Subject: Dow Chemical Company- Response to the Request for Additional Information for the renewed license of the TRIGA research reactor. License No. R-108; Docket No. 50-264

DTRR response to questions 7, 14, 16, 18, 19, 24, 29 and 53

Aug 2011

Figure 29.2 Control system block diagram

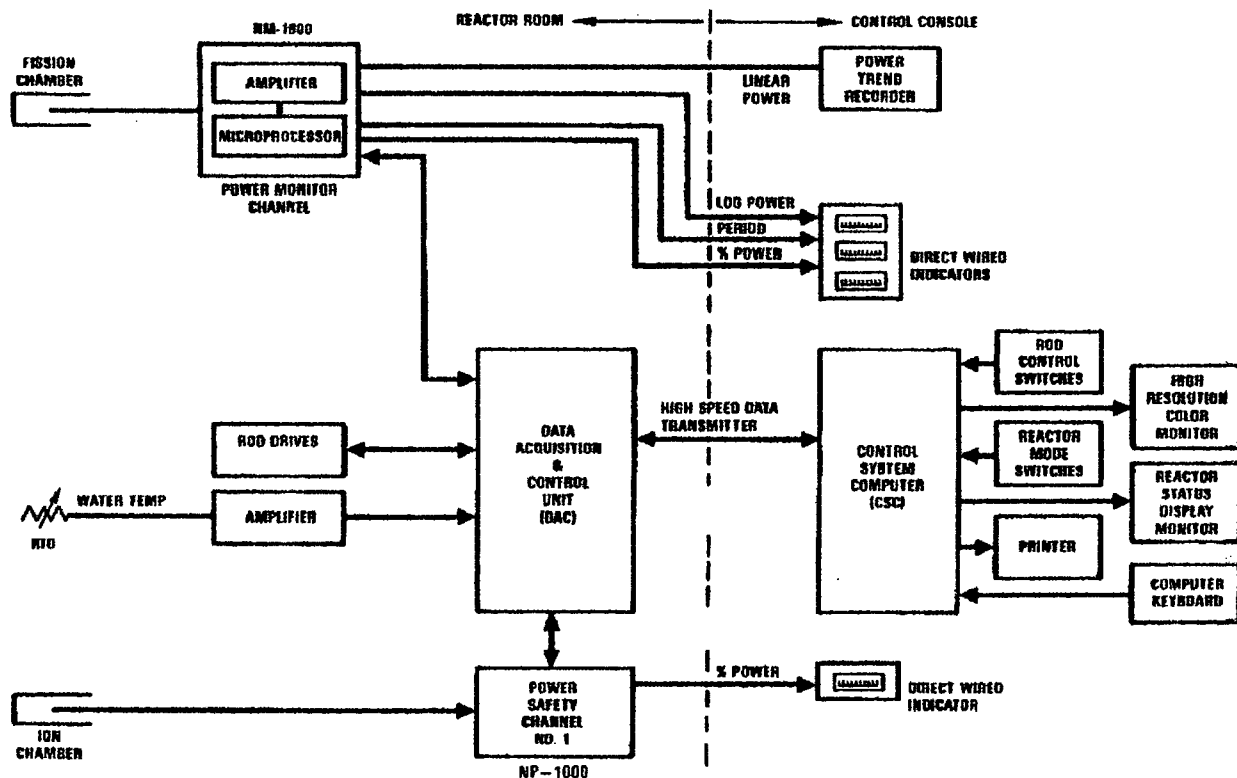
29. NUREG-1537, Part 1, Section 7.2, "Design of Instrumentation and Control Systems" requests the applicant to provide information regarding the basis for evaluating the reliability and performance of the I&C systems. DTRR SAR, Chapter G, does not provide sufficient information.
 - 29.1 Please describe the design basis for the I&C system.
 - 29.2 Please provide a system description that includes block, logic, and schematic diagrams of the I&C system.
 - 29.3 Please describe the methodology and acceptance criteria used to establish and calibrate the trip and actuation setpoints or interlock functions.
 - 29.4 Please summarize how the system design is sufficient and suitable for performing the functions required for operation at the new requested power level.

29.2 The block diagram of the Instrument and control system for the DTRR is shown in Figure 29.2 below. As described in response to RAI 29.1 above, the system is based on an industry standard. Operational experience shows that it is capable and sufficient to control the DTRR for the reactor power level of 300kW. It has the following main parts: The NM1000 and the NPP1000 with their associated sensors, signal conditioning amplifiers and integrated circuits and power supplies; The Data Acquisition Computer; The Control System Computer; And the Control Console.
